URBAN DESIGN COMMENTS

Site Address: Tudor Lodge Hotel, 50 Field End Road, HA5 2QN
Planning ref: 4726/APP/2023/2216
Case Officer: Nesha Burnham
Design Officer: Joris van der Starre
Date of comments: 04/10/23
Proposal: Alteration to car parking layout, resurfacing and expansion of hardstanding. Installation of a sunken paving area with pergola and a standalone outbuilding for WC and store. Installation of a staff cycle shelter. Erection of a boundary fence and planting against Field End Road. Various landscape planting and paving to external pergola sitting area.

[Architect's comments 20/02/2024_comments](#)

FIG. 4 – Arboriculture impact assessment and method statement by Cantia

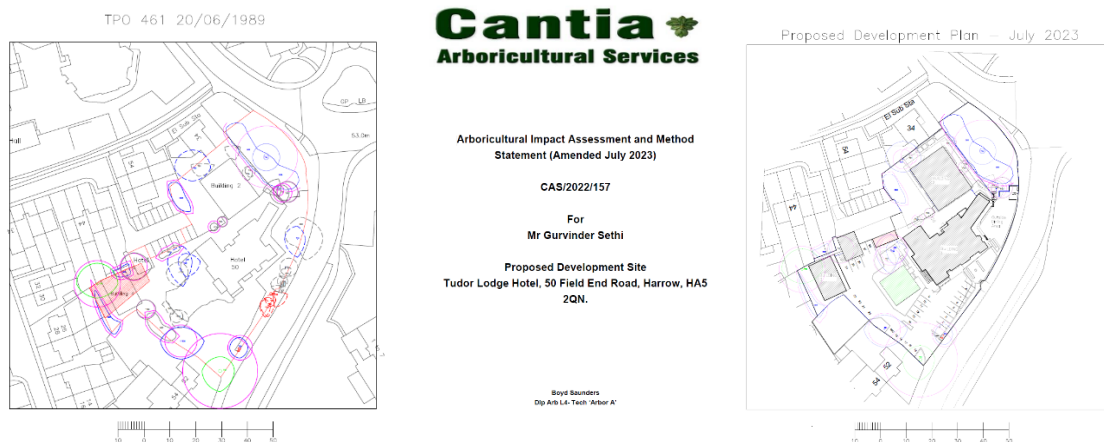
There is insufficient information regarding the trees proposed to be removed and those recently removed, but without it the current proposals are not considered acceptable. A detailed arboricultural report is required.

JW: Cantia's Arboriculture impact assessment and method statement were submitted as part of the application.

FIG. 7 – landscape design query to case officer Nesha Burnham requesting clarity for proposed boundary planting in email on 20/10/2023. This email was forward to Niamh McMenamin on 08/02/2024 which we did not received response.

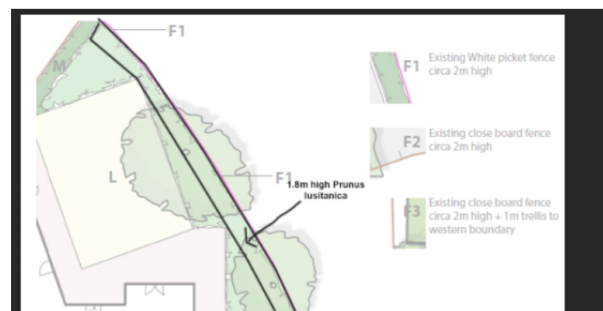
Regarding planting – Specifically the boundary to Field end road.

It is preferable to introduce a new *Prunus lusitanica* hedge along this boundary to aid privacy.

This will be in addition to the plan produced.

Fig 8 – revised pergola design

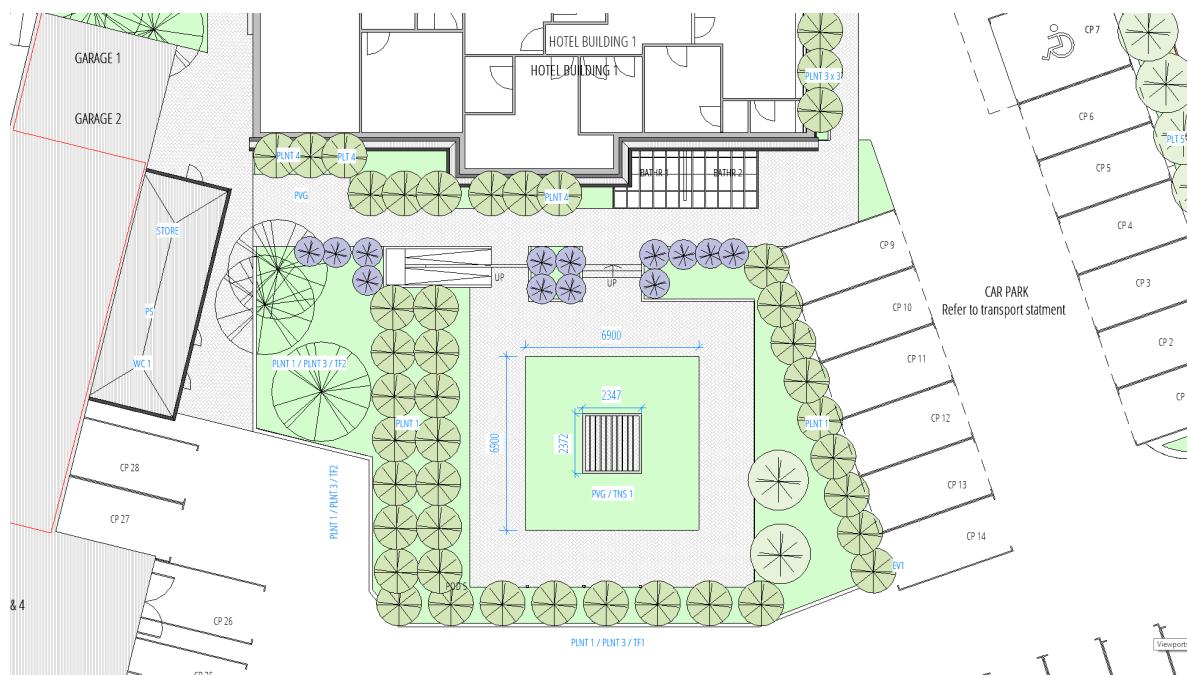
The proposed 'pergola' is not what is normally considered a pergola; a light, open, wooden structure that would allow views and light to penetrate throughout. Instead, a large building of 11m by 11m is proposed with a solid green roof is proposed, resulting in a dark area underneath and blocking views towards the listed building. This is exacerbated by the proposed planting immediately adjacent and 2m tall ivy fences at close proximity. All these objects would reduce the visibility of the adjacent listed building and reduce the currently more open character of the setting. These elements are therefore not supported.

JW: The visibility issue has been elaborated on Fig 1. The proposed 'pergola' size has been reduced from 11 x 11m to 6.9x 6.9m, with the central area of 2.3 x 2.3m free from green roof (Fig 8). Please confirm this design is acceptable.

Fig 9 – WC / Storage building with material key drawing no. A204

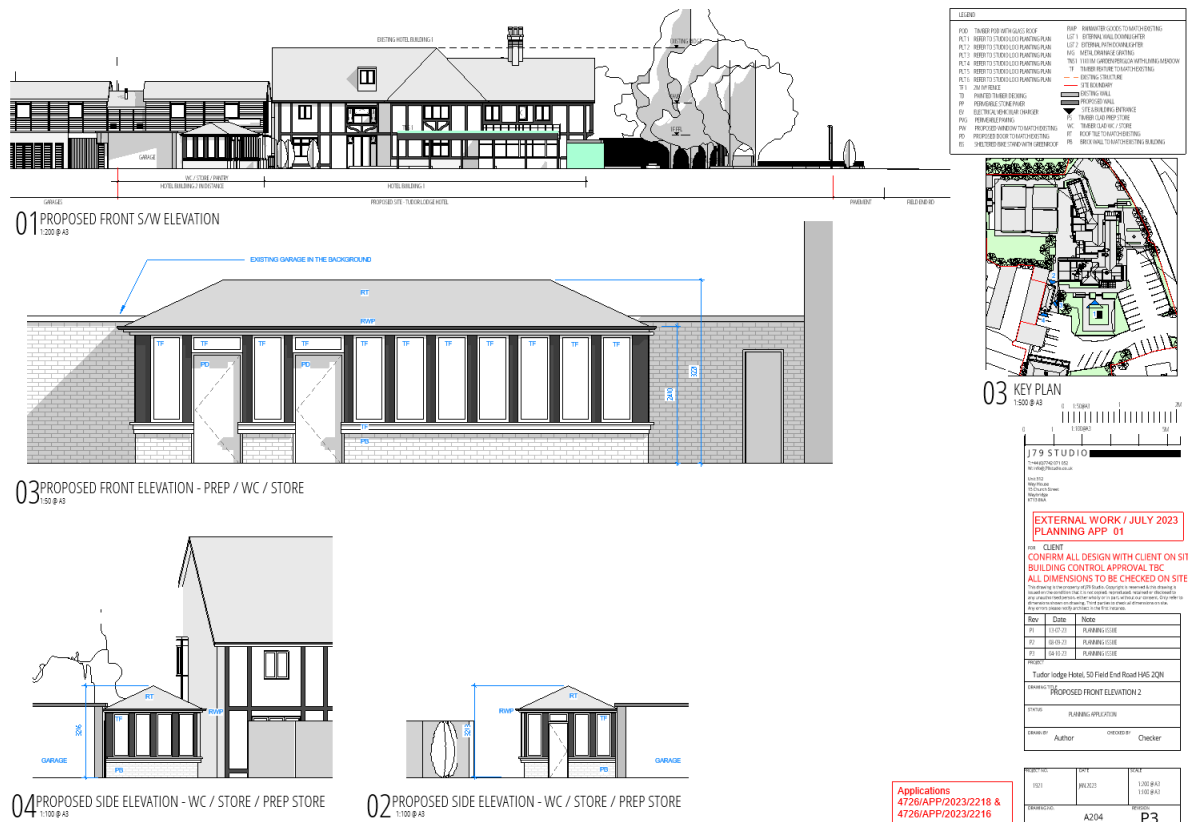
The proposed wc/storage building could be acceptable in design, although further details on the materials and colours are requested.

JW: Many Thanks. The proposed materials are marked on drawing A204.
